REMARKS

In this Amendment, Applicants amend the drawings and the specification. Applicants submit that the amendments contain no new matter, in accordance with the requirements of 37 C.F.R. § 1.121(f). Upon entry of this amendment, claims 1 – 19 remain pending, with claims 1 – 7 and 16 – 19 withdrawn from consideration as drawn to a nonelected invention, and claims 8 – 15 under current examination.

FIG. 12B
(PRIOR ART)

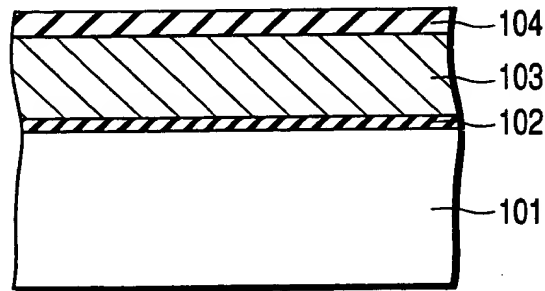
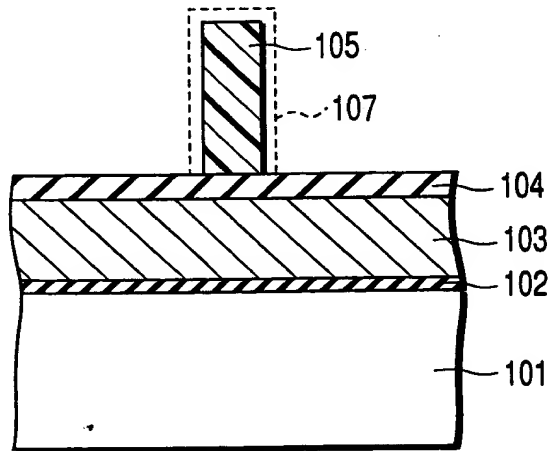
The Examiner objected to the drawings, stating that Figs. 10 – 12 and 15 – 17 should be designated by a legend, such as “prior art.” The Examiner also objected to Fig. 12B as failing to comply with 37 C.F.R. 1.84 (p)(4), “because reference character “105” has been used to designate both a *resist pattern* and a *width reduced pattern*” (Office Action, page 2, italics in original).

Applicants have amended Fig. 12B to replace item 105 with a new reference 107, as follows: “a resist pattern ~~[[105]]~~ 107 (a portion indicated with a dashed line) is formed.” Applicants submit that this overcomes the Examiner’s objection to Fig. 12B and thereby satisfies the requirement for a proposed drawing correction.
